Service Bulletin No: 51-001

ATA Chapter: 51

**AIRCRAFT STRUCTURE - GENERAL****DO A CHECK OF THE MATERIAL SPECIFICATION USED DURING MANUFACTURE AND, IF NECESSARY, DO A CHECK FOR CRACKS OR REPLACE THE PART****1. Planning Information****A. Effectivity**

**Inspection and, if necessary, Replacement of the Shackles on the Elevator Control Cable**  
Figure 15

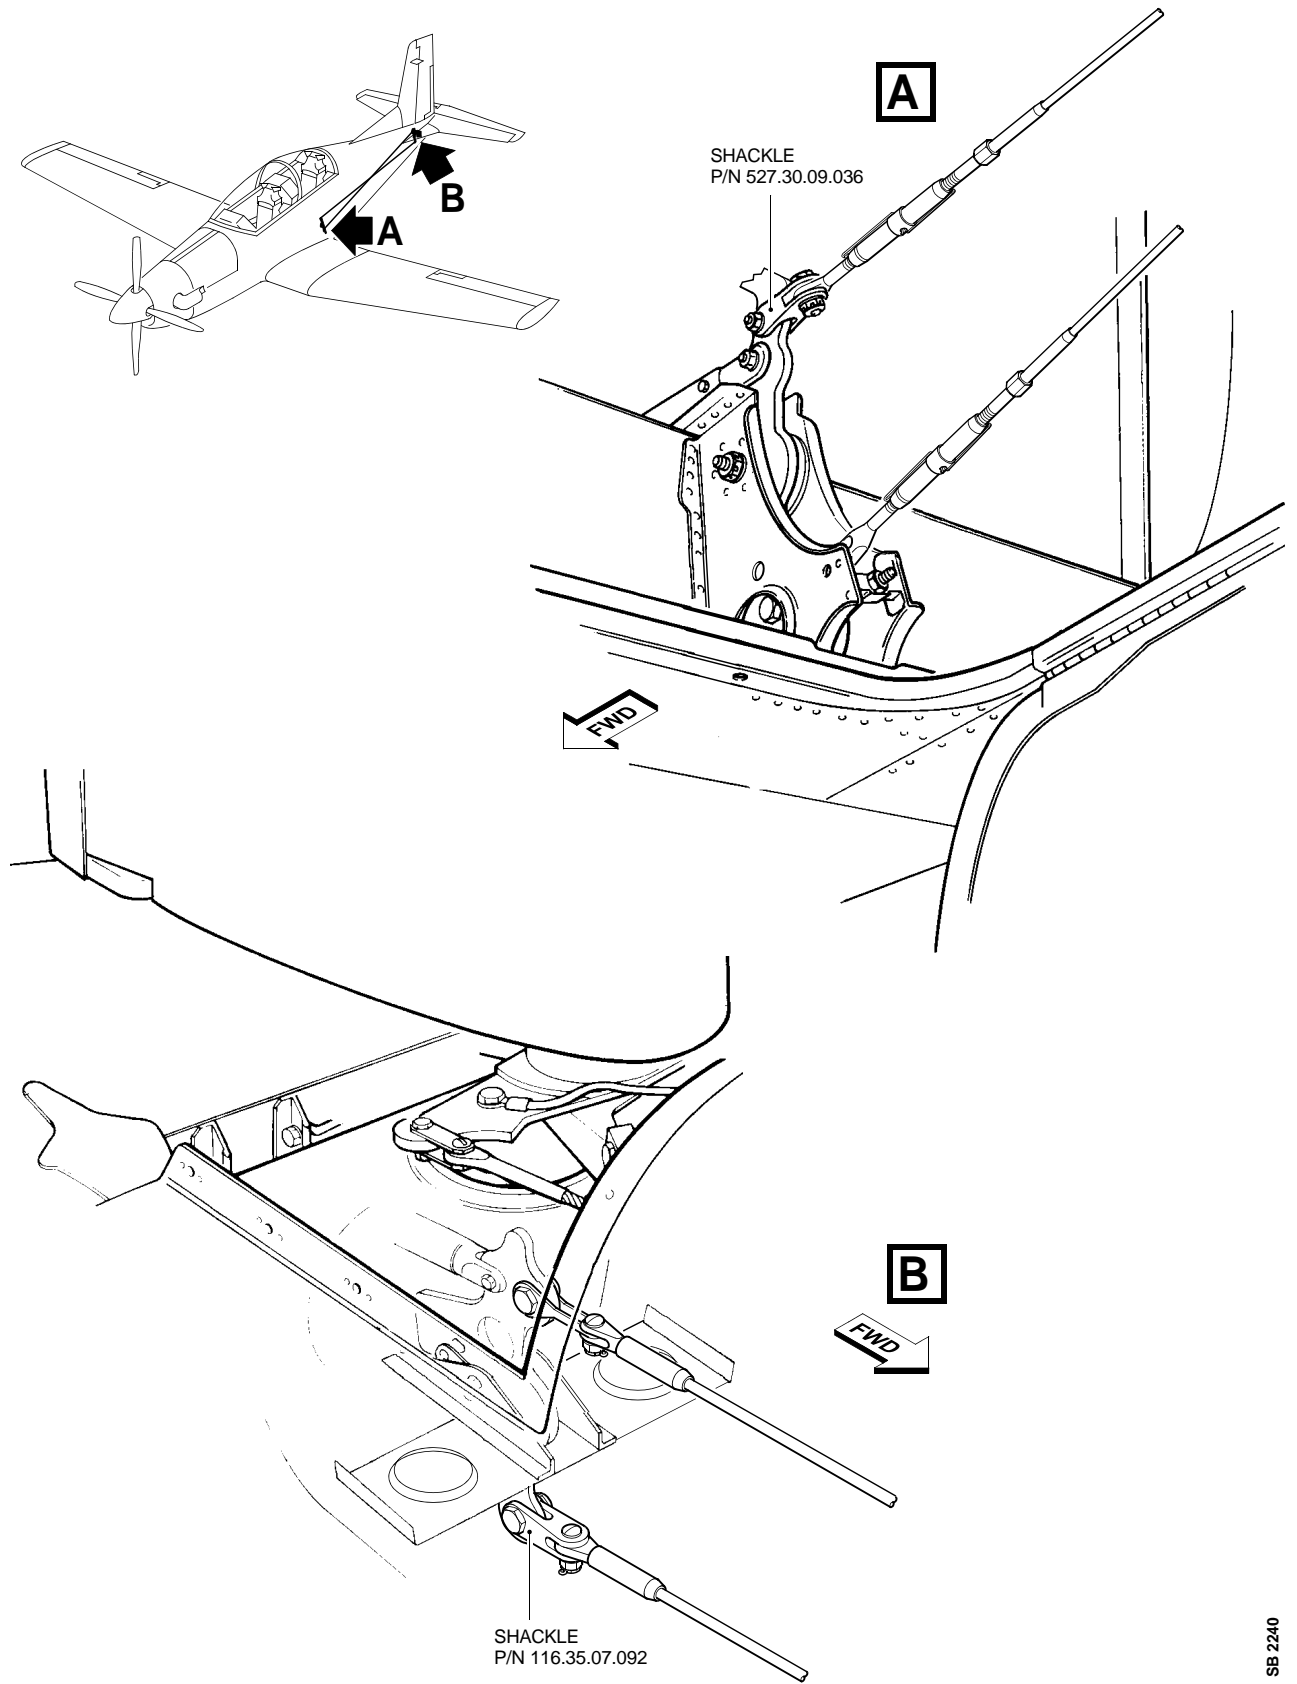
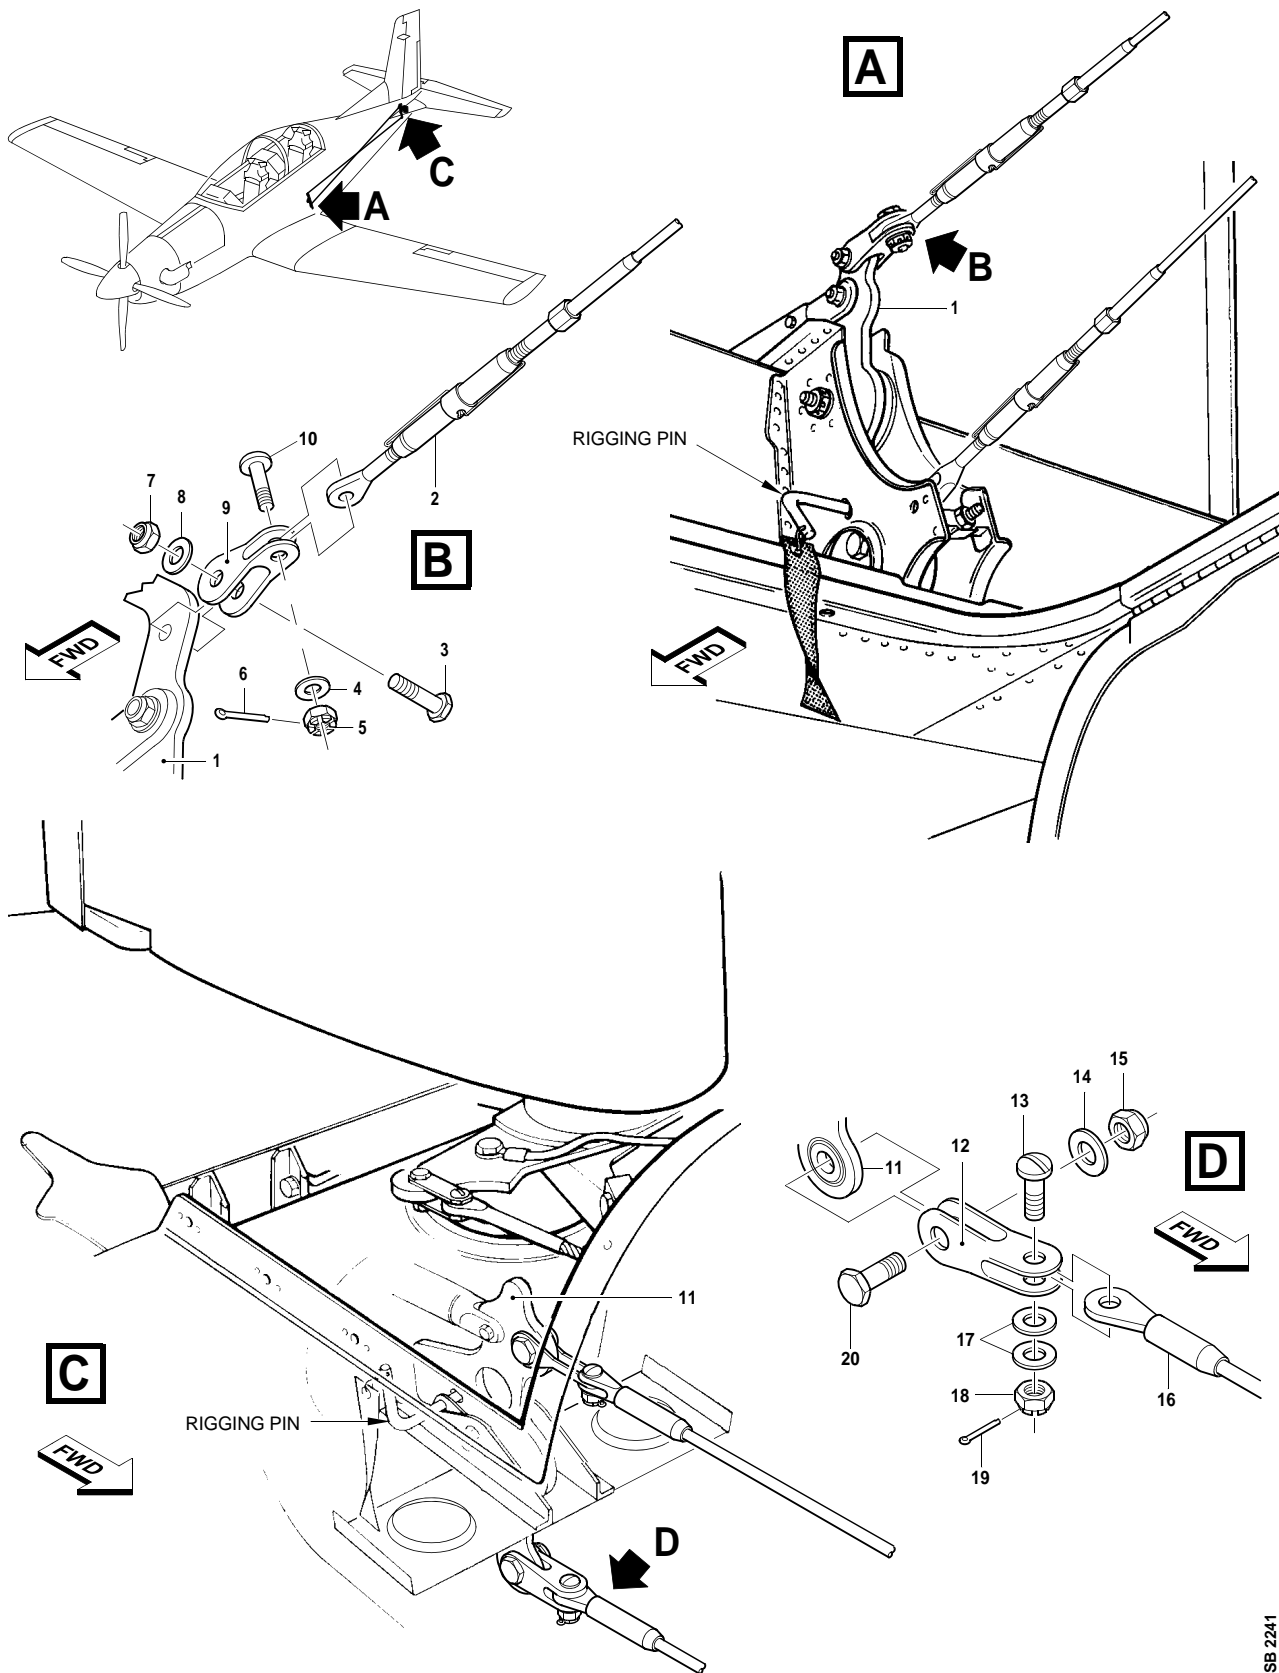
- 3 At the front lever, identify the control cable (2) (P/N 527.30.09.005).
- 4 Remove and discard the locking clips from the turnbuckles (Refer to AMM, 27-20-02 for further information).

- 5 Loosen the turnbuckles to release the tension from the control cable (2) (P/N 527.30.09.005).
- 6 Remove, and discard, the cotter pin (6).
- 7 Remove the nut (5), the washer (4) and the bolt (10) that connect the shackle (9) to the control cable (2).

- 8 Remove the nut (7), the washer (8) and the bolt (3) that connect the shackle (9) to the lever (1).
- 9 Remove, and discard, the shackle (9) from the aircraft.

- 11 Put the new shackle (9) (P/N 527.30.09.229) in position between the lever (1) and the cable (2).
- 12 Put a layer of the corrosion preventative (Material No. P04-039) on the shank of the bolt (3).

- 13 Install the bolt (3), the washer (8) and the nut (7) that connect the shackle (9) to the lever (1).
  - 14 Install the bolt (10), the washer (4) and the nut (5) that connect the shackle (9) to the cable (2).
  - 15 Safety the nut (5) with the new cotter pin (6) (P/N 940.17.02.340).
  - 16 If the shackle (P/N 116.35.07.092) is made from AA2024-T351, continue this Service Bulletin from Step 3.B.(8)(f).
  - 17 If the shackle (P/N 116.35.07.092) is made from AA2124-T851, continue this Service Bulletin from Step 3.B.(8)(f)15.
- (f) Replace the shackle (P/N 116.35.07.092) (Ref. Fig. 15 and Fig. 16):

**NOTE:** Step 3.B.(8)(f) is only applicable to shackles (P/N 116.35.07.092) made from AA2024-T351.

- 3 At the rear lever (11), identify the control cable (16) (P/N 527.30.09.005).
- 4 Remove and discard the locking clips from the turnbuckles (Refer to AMM, 27-20-02 for further information).

- 5 Loosen the turnbuckles to release the tension from the control cable (16) (P/N 527.30.09.005).
- 6 Remove the nut (15), the washer (14) and the bolt (20) that connect the shackle (12) to the lever (11).

- 7 Remove, and discard, the cotter pin (19).
- 8 Remove the nut (18), the washers (17) and the bolt (13) that connect the shackle (12) to the control cable (16).

**NOTE:** Pull the control cable (16) rearwards to make the removal of bolt (13) easier.
- 9 Remove, and discard, the shackle (12) from the aircraft.
- 10 Use the absorbent paper (Material No. P02-031) made moist with the solvent (Material No. P01-010) and clean the attachment points on the lever (11) and the cable (16).

- 11 Put the new shackle (12) (P/N 527.30.09.231) in position between the lever (11) and the control cable (16).

- 12 Install the bolt (13), the washers (17) and the nut (18) that connect the shackle (12) to the control cable (16).
- 13 Safety the nut (18) with the new cotter pin (19) (P/N 940.17.02.340).
- 14 Put a layer of the grease (Material No. P04-028) on the shank of the bolt (20).
- 15 Install the bolt (20), the washer (14) and the nut (15) that connect the shackle (12) to the lever (11).
- 16 Do the elevator control system, adjustment / test (Ref. AMM, 27-30-00, Page Block 501).
